## PROPOSED MODIFICATION NWB IN-PIT TAILINGS DISPOSAL COMMENT RESPONSES

Updated results (version 3) for contaminant transport model

September 25 th, 2018

#### Discussion – Model boundary conditions

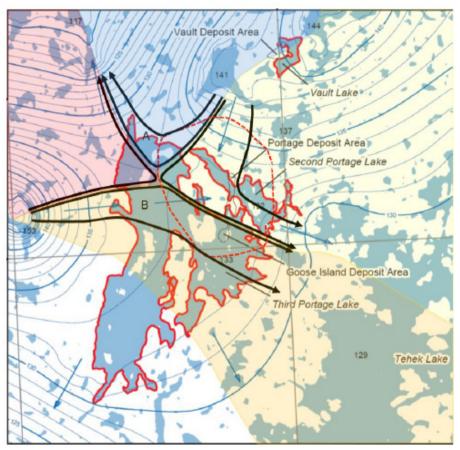
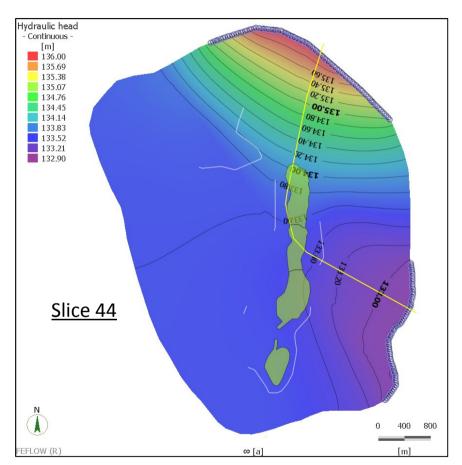
Groundwater flowpaths in sub-permafrost groundwater based on Golder (2004) modelling results.

SNC sub-permafrost conditions (-500 masl)

#### Discussion – Boundary conditions at the bottom of the model

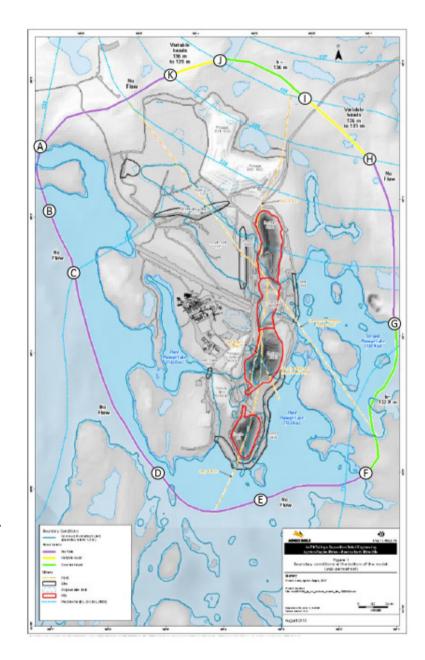
Section	Version 3	NR-Can
A-B	No Flow	136.6
B-C	No Flow	No Flow
C-D	No Flow	133.6-132.2
D-E	No Flow	No Flow
E-F	No Flow	132.9-132.7
F-G	132.9	132.7-132.9
G-H	No Flow	No Flow
H-I	135-136	135.6-136.6
I-J	136	136.6
J-K	136-135	135.6-136.6
K-A	No Flow	No flow

C-D: no flow to be aligned with regional model flow.

E-F: no flow to keep same model logic under 3PL

F-G: suggest to used 2PL elevation.

F-G - H-I + I-J + J-K: driven by Turn Lake elevation no field measurement supporting this change
